Planning Committee

Wednesday, 4 August 2021, 6.00pm

CITY OF FREMANTLE
NOTICE OF A PLANNING COMMITTEE MEETING

**PC2108-1 HERBERT STREET, NO. 11 (LOT 13) NORTH FREMANTLE –
ALTERATIONS AND ADDITIONS TO EXISTING SINGLE HOUSE (TG
DA0231/21)**

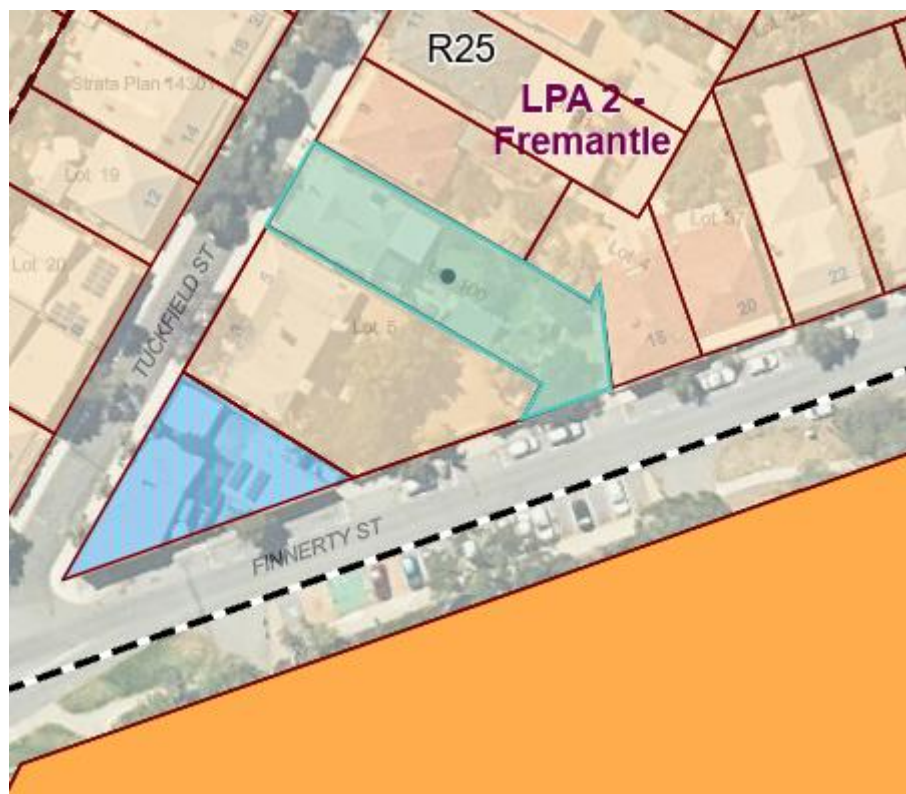
In response to concerns raised by the City's Heritage team with respect to how the proposed dwelling responds to the surrounding heritage listed streetscape and concerns with respect to the proposal satisfying the relevant planning requirements for the site, the applicant prepared amended plans on 6 July 2021 comprising the following:

- Increasing ground floor and upper floor street setbacks.
- Reduction in height and scale of the building.

- Removal of upper floor dormer windows from the proposal.
- Reducing the roof pitch.
- Providing the upper floor predominantly within the roof area.
- Rotating the main façade to be parallel with the street.
- Reduction in height and scale of eastern and western boundary walls.
- Reducing the bulk and scale of the ground floor façade.

The applicant submitted a further set of amended plans on 6 July 2021 including the following amendments:

- Lowering the verandah an additional 200mm.
- Increasing the setback of the upper floor deck.
- The inclusion of garden beds in front of the dwelling to delineate the property line.

Image 2: Applicants perspective diagram

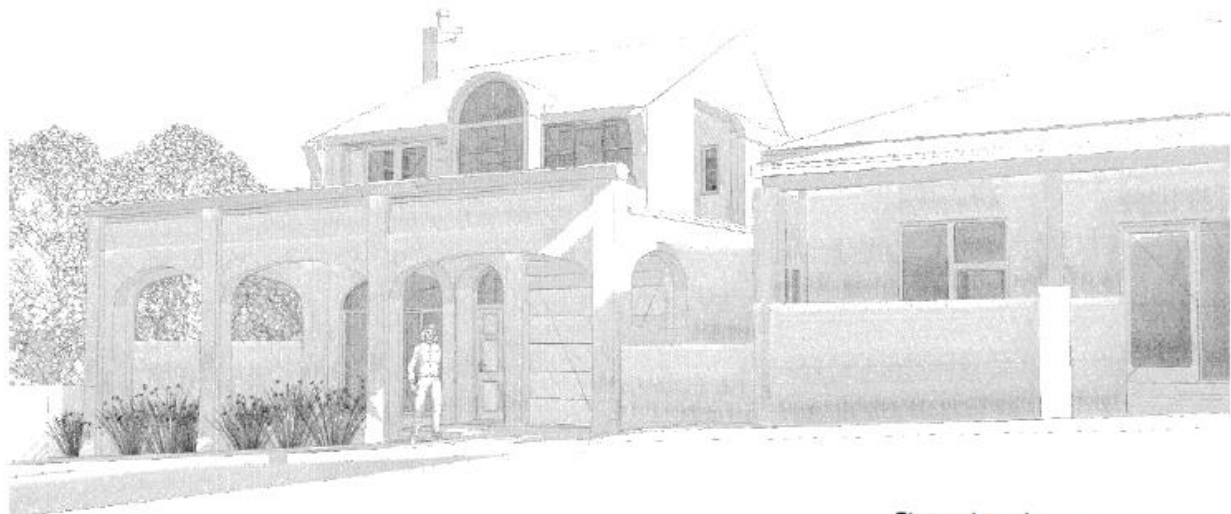
It is acknowledged that the applicant has amended the plans, including reducing the overall height of the dwelling and the steepness of the roof, in an attempt to address Officers' concerns that the design 'overwhelmed' the Finnerty Street streetscape, however officers still have the following concerns:

Image 5: Diagram depicting the extent of proposed buildings up to property boundaries

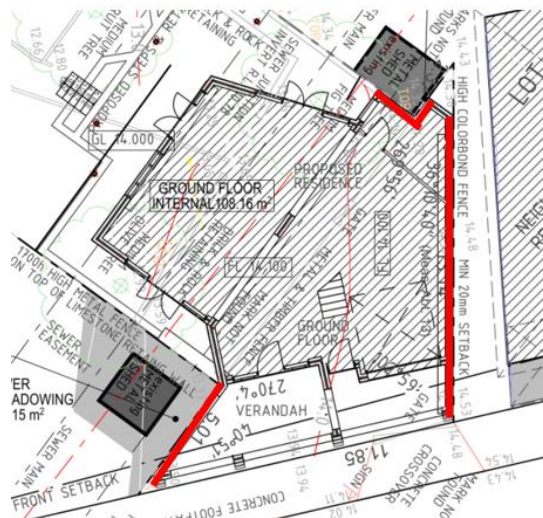
The north-western wall of the verandah is considered to meet the Design principles of LPP 2.4 in the following ways:

- The wall is single storey and adjoins the extended rear yard of the neighbouring property, resulting in limited building bulk impact to this property as this area is used for an outbuilding.
- The shade cast by this boundary wall will fall over the street.
- The wall results in part from a response to align the development to the street and provide a verandah across the front property boundary.

Image 6: The portion of the building above the relevant deemed-to-comply height requirement highlighted in yellow.

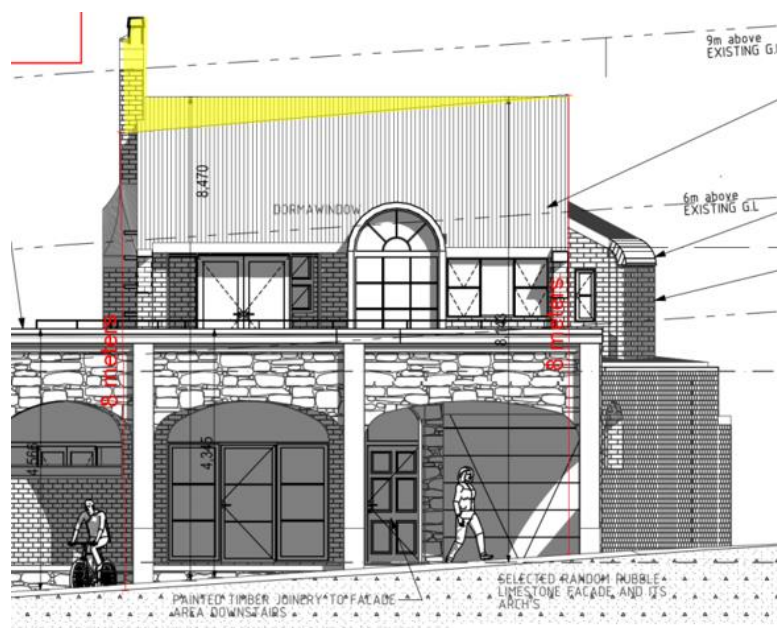
Considered in isolation, the area of the dwelling which exceeds the building height requirements that apply to the site is considered minor and worthy of support, however in the context of the reduced upper floor street setbacks this height is considered to contribute to the impact of the building on the streetscape and the development is therefore not considered to satisfy the Local Planning Scheme 4 sub area 2 requirement for the height of buildings to not be detrimental to the amenity of the area and not have an undue heritage impact.
